# BCA Assessment Report

**Schematic Design Phase**  
Temora Hospital Redevelopment

**Revision 1**  
01 February 2024  
Reference: 230267

Figure No. 3: Required fire compartmentation of patient care areas.

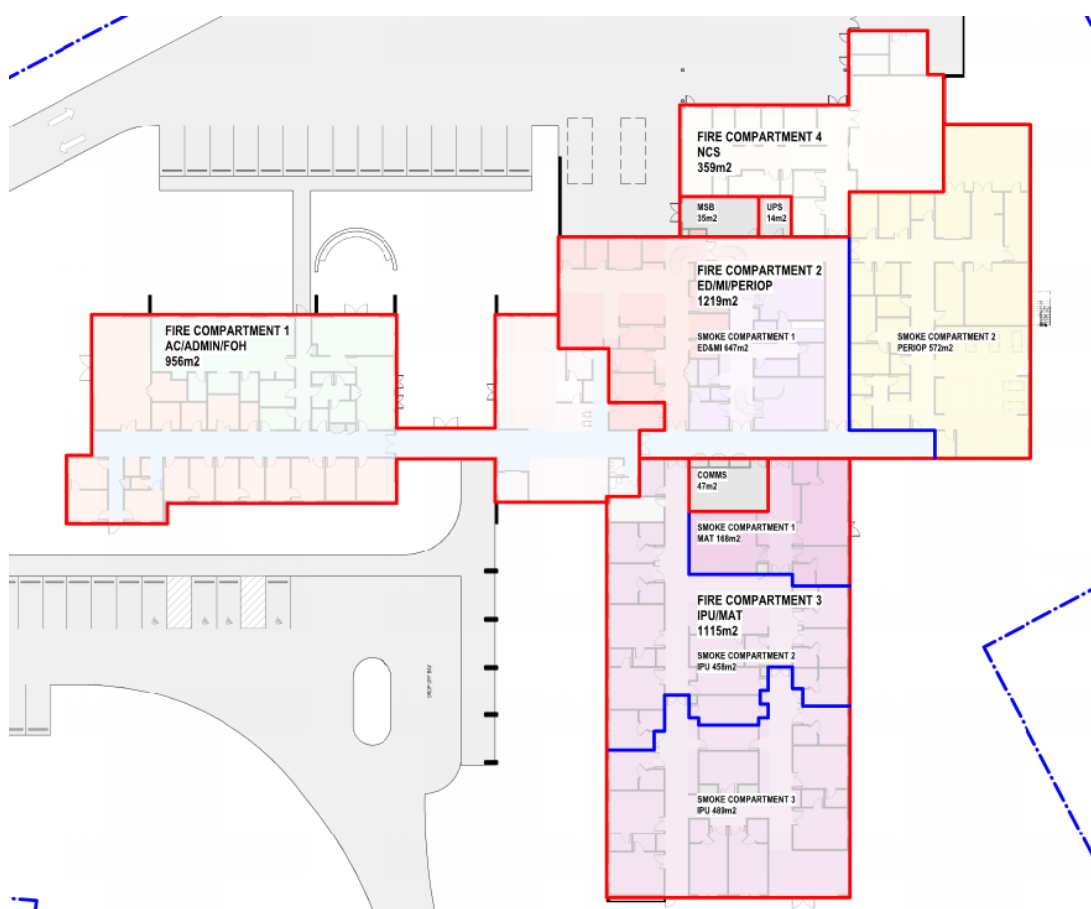
The current Schematic Architectural Drawings indicate the provision of four (4) separate fire compartments, each of which are less than 2,000m<sup>2</sup> in floor area as indicate in the figure below.

Figure No. 4: Required fire and smoke separation of non-patient care areas from patient care areas.

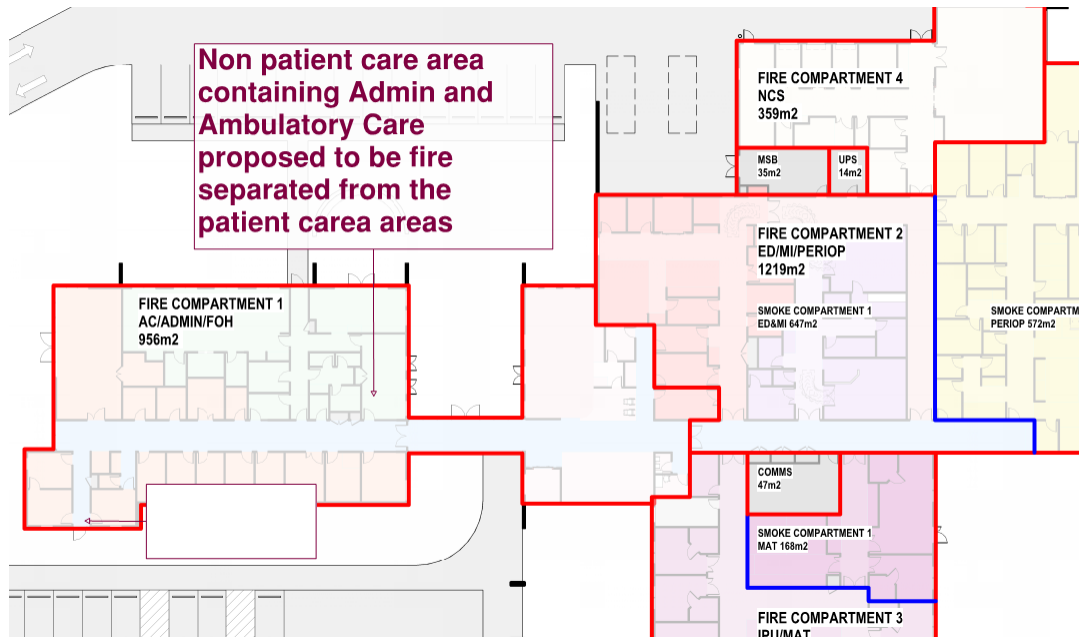
- + Ancillary use spaces are required to be 1-hour fire separated from patient care areas. Ancillary use spaces in a Class 9a comprise:
  - ▶ A kitchen and related food preparation areas having a combined floor area of more than 30m<sup>2</sup>.
  - ▶ A room containing a hyperbaric facility.
  - ▶ A room used predominately for the storage of medical records having a floor area of more than 10m<sup>2</sup>.
  - ▶ A laundry, where items of equipment are the type that are potential fire sources (e.g., gas fire dryers).

Figure No. 5 – Locations of exposure of external walls of different fire compartments

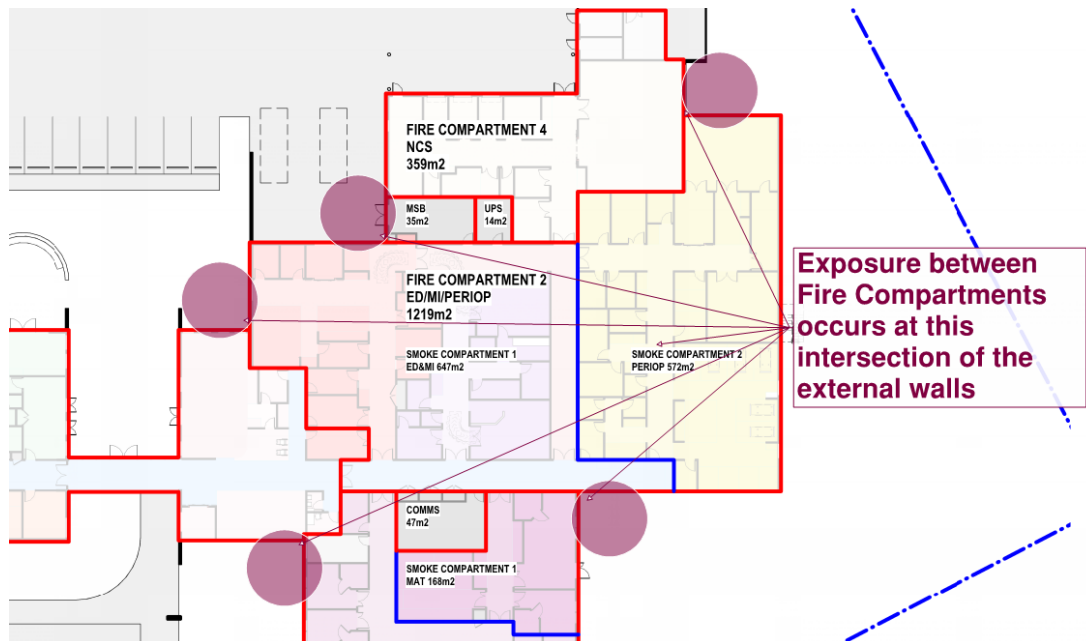
Having regard to the proposed design, the following figure details where exposure occurs between different fire compartments.

The external walls and associated openings will be required to be protected in accordance with the DTS Provisions of the BCA or alternatively the protection of the openings will be required to be subject of a Fire Engineering Assessment to be undertaken by Arup in order to demonstrate compliance with the nominated Performance Requirements of the BCA.

Figure No. 6 – Fire safety doors that swing against the direction of egress

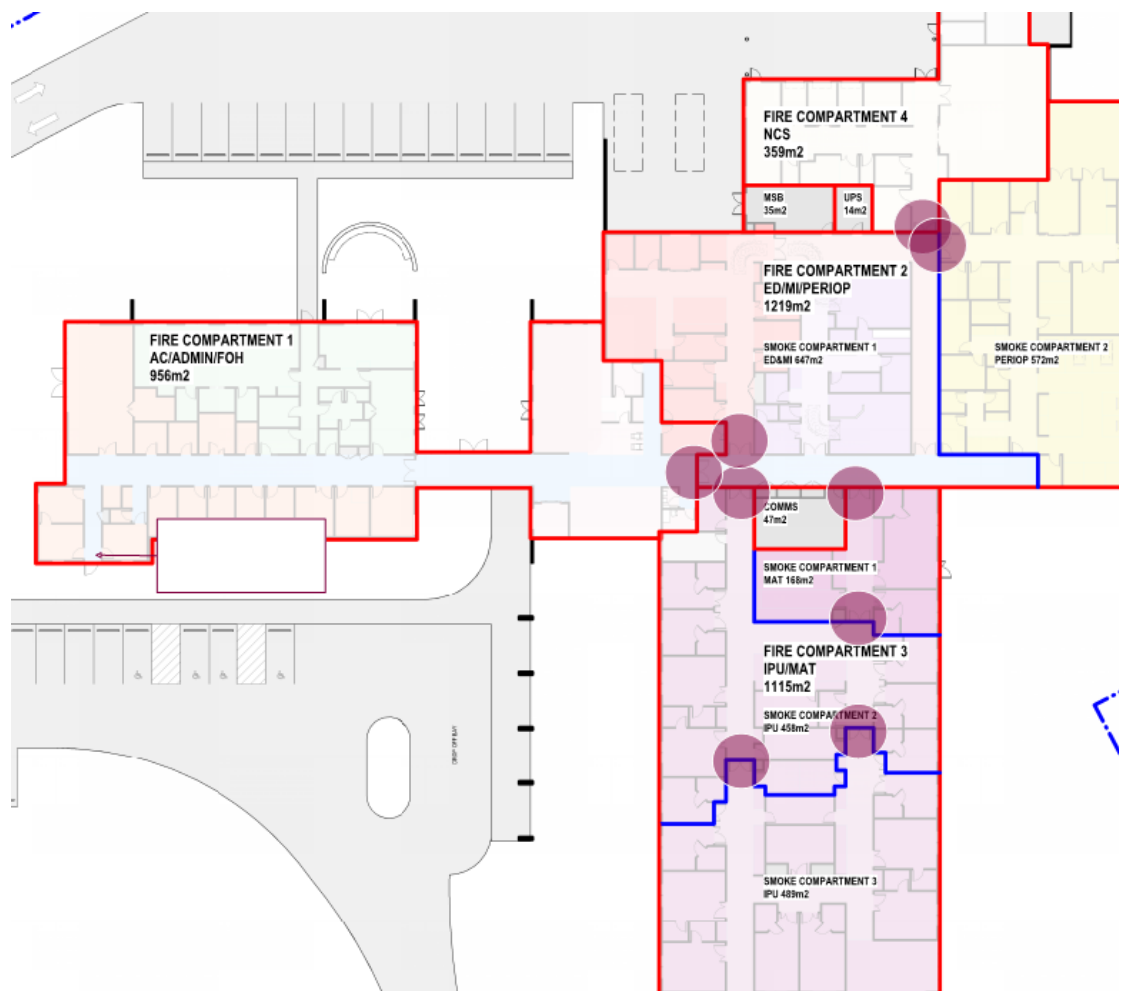
The below figure details the locations throughout the building of fire safety doors that are proposed not to swing in the direction of egress.

Figure No. 8 – Egress through the Ambulance Bay from the exit serving ED

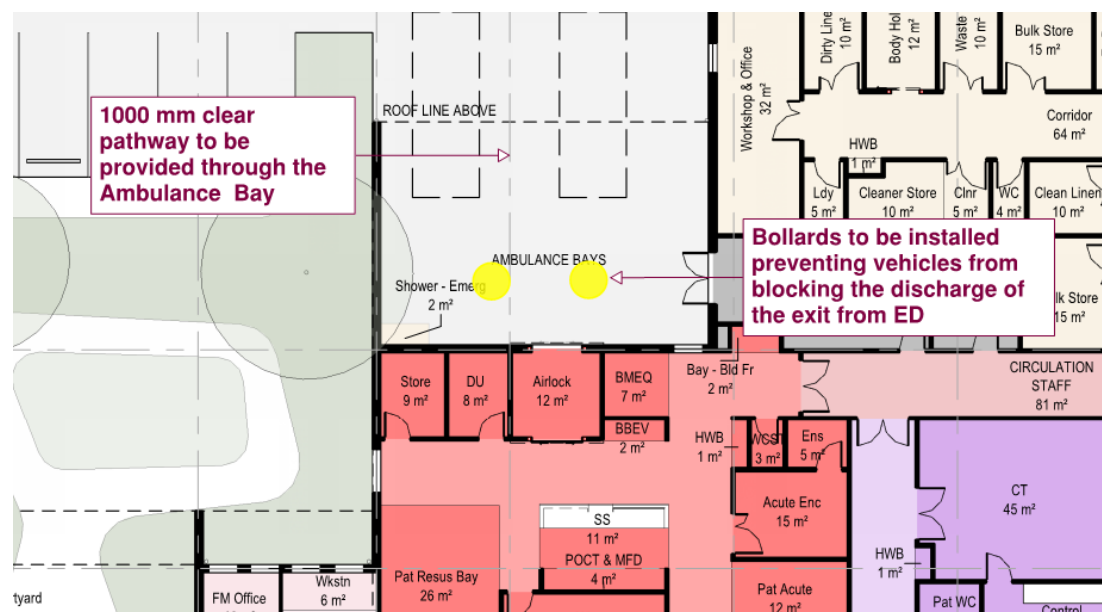
Furthermore, an exit pathway with a clear unobstructed width of 1000 mm will be required to be provided from each of the exits upon discharge leading occupants to the public roadway(s).

Figure No. 15: Horizontal exit doors that do not swing in the direction of egress.

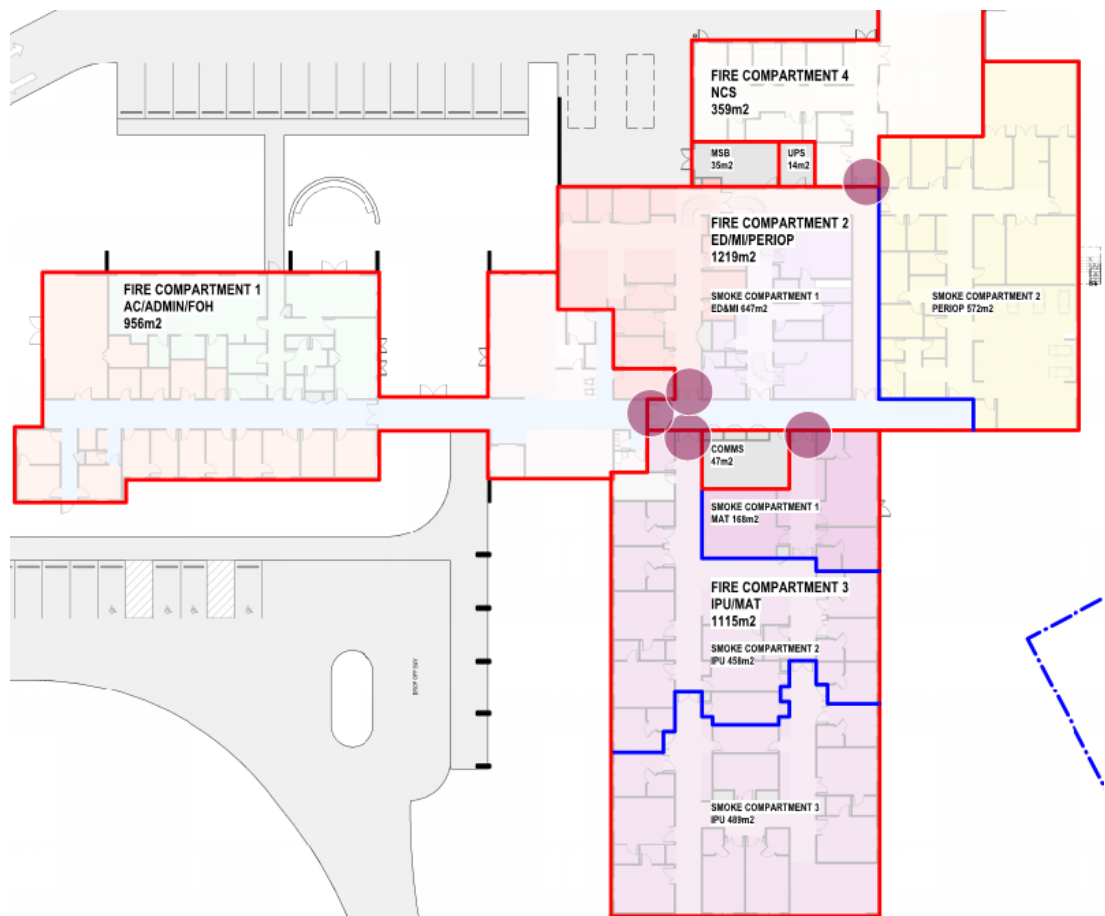
<b>D3D25</b>	<p><b>Swinging Doors:</b></p> <p>All exit doors or doors forming part of a required exit are required to swing in the direction of egress.</p> <p>The Schematic Architectural Drawings indicate that all swing doors discharging to open space swing in the direction of egress.</p> <p><i>Swing of Horizontal Exit Doors</i></p> <p>All exit doors including horizontal exit doors are required to swing in the direction of egress.</p> <p>There are several fire doors used as horizontal exits that are proposed to not swing in the direction of egress in certain instances i.e., doors will swing in one direction only as detailed in the figure below.</p>

The swing of the horizontal exit doors will be required to be assessed as part of the Fire Engineering Assessment to be undertaken by Arup to demonstrate compliance with the nominated Performance Requirements of the BCA

Figure No. 21: Doorways and corridors that require review to ensure that compliant circulation space and turning circles is provided.

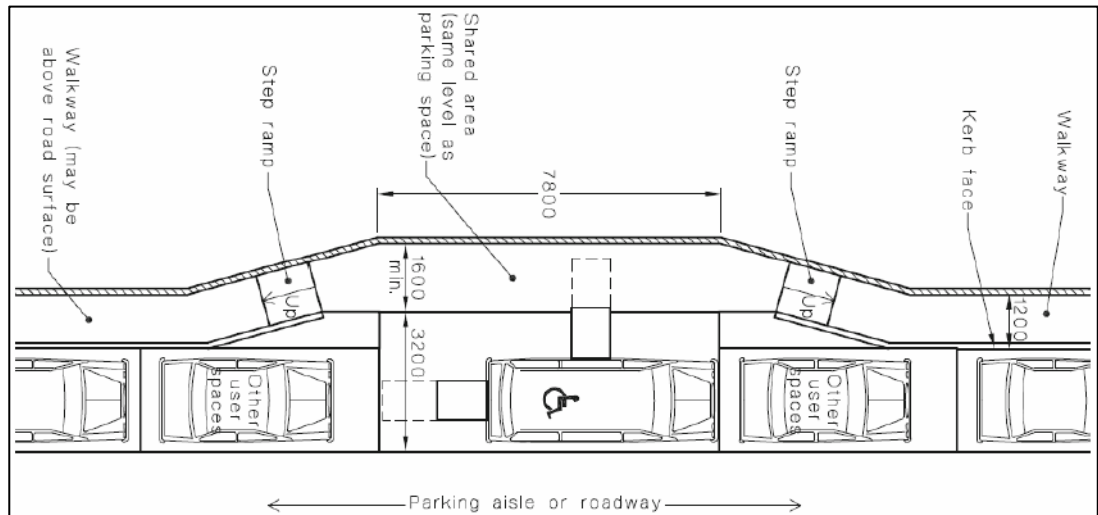
The following figure detail's locations throughout the building where latch side clearance and turning circles at the end of corridors requires attention to ensure compliance.

Figure No. 42: Proposed location of the fire hydrant booster relative to the principal pedestrian entrance and vehicle entrance

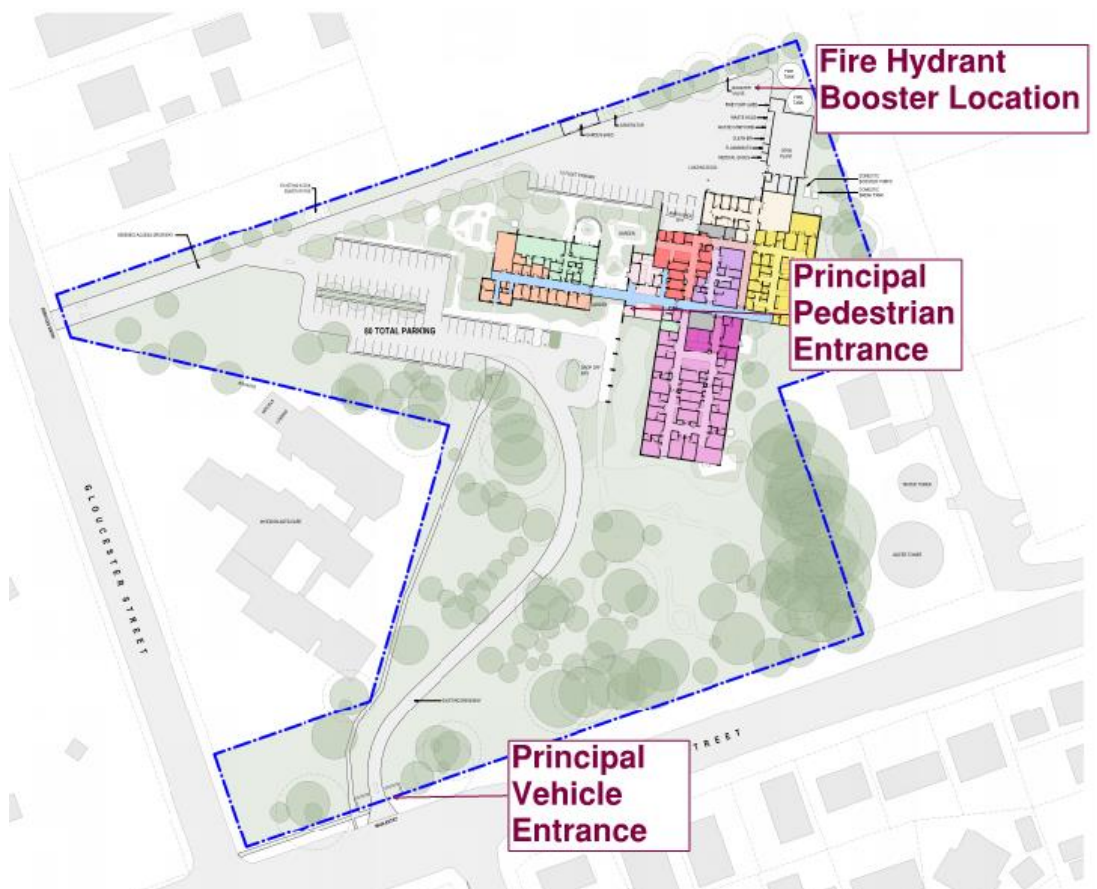
Having regard to the proposed design which considers the existing site circumstances and the setback of the building from the street frontage, the fire hydrant booster assembly is not proposed to be located in accordance with the requirements of AS 2419.1 – 2021. The location of the fire hydrant booster is indicated in the figure below.

The location of the fire hydrant booster will be required to be assessed as part of a Fire Engineering Performance Solution to be prepared by Arup in order to demonstrate compliance with the nominated Performance Requirements of the BCA.

Figure No. 43: Fire separated Comms Rooms will not be provided with compliant fire hose reel coverage.

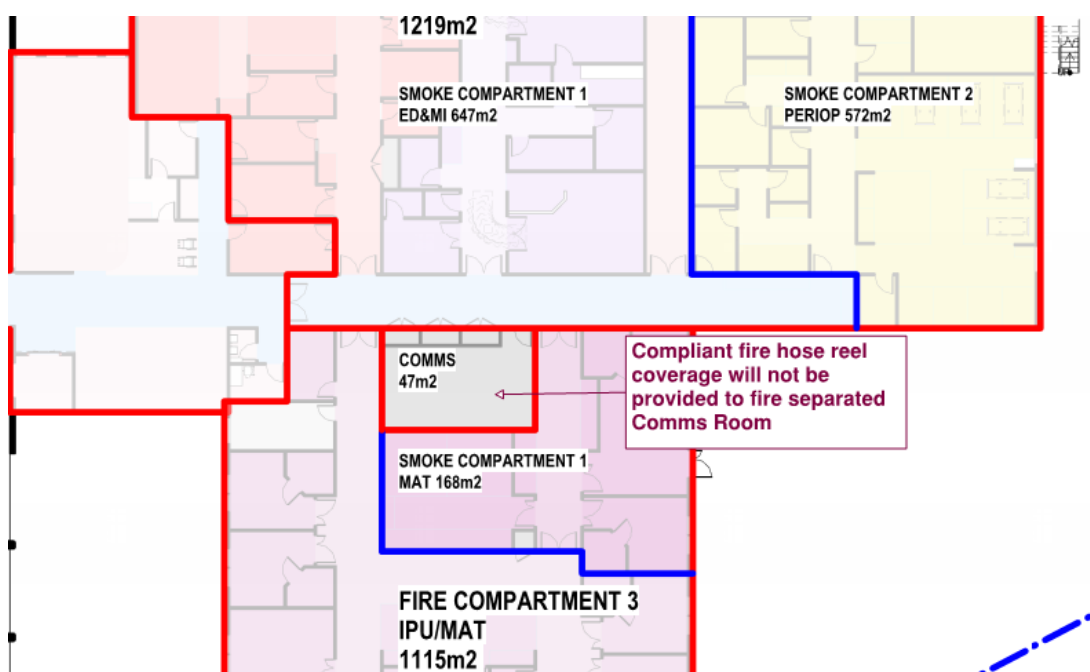
In this instance, the omission of Fire Hose Reel coverage to the fire separated isolated room will be required to be assessed as part of the Fire Engineering Assessment to be undertaken by Arup to demonstrate compliance with the nominated Performance Requirements of the BCA.

Figure No. 43: Proposed location of the fire sprinkler booster relative to the principal pedestrian entrance and vehicle entrance

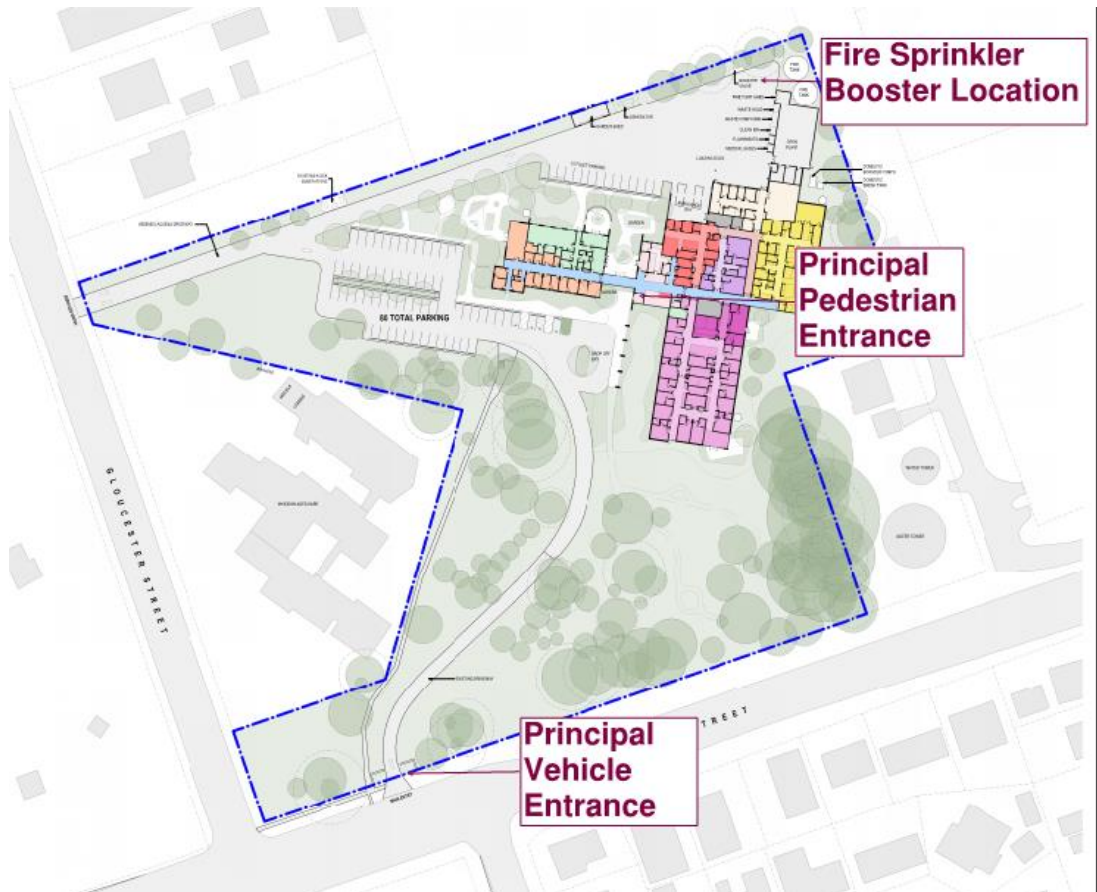
- + Not more than 10m from a hardstand
- + Not less than 10m from:
  - ▲ Any high voltage electrical distribution equipment such as transformers and distribution boards
  - ▲ Any electric vehicle charging station regardless of voltage.
  - ▲ Any stored quantity of dangerous goods
  - ▲ Any external combustible storage
- + Not less than 3m from the vent terminal of any gas assembly or gas measurement systems
- + Not less than 3m from the discharge outlet of any building exhaust system when operating in fire mode.

Figure No. 54: Required provision of sanitary facilities for a person with a disability

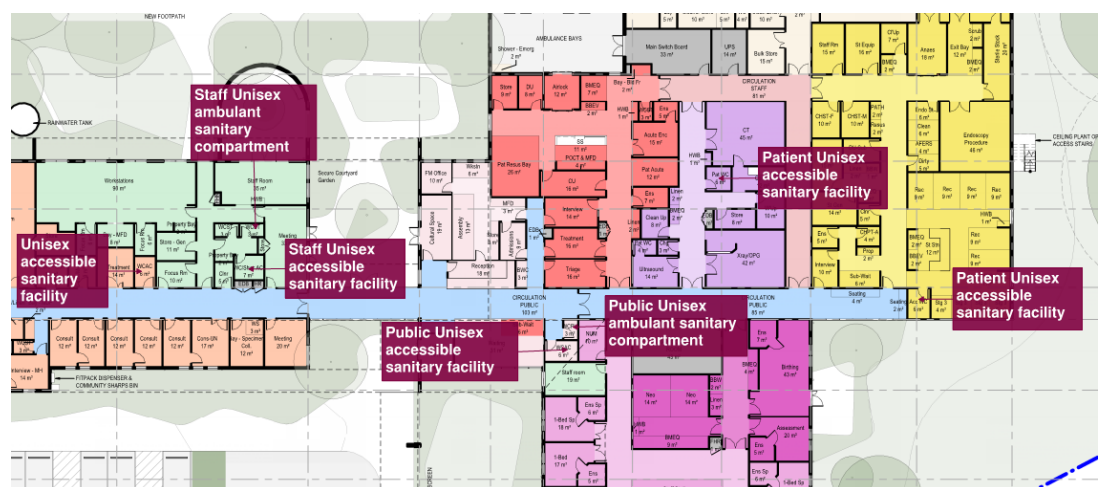
The below figures indicate the required provision of accessible sanitary facilities for a person with a disability:
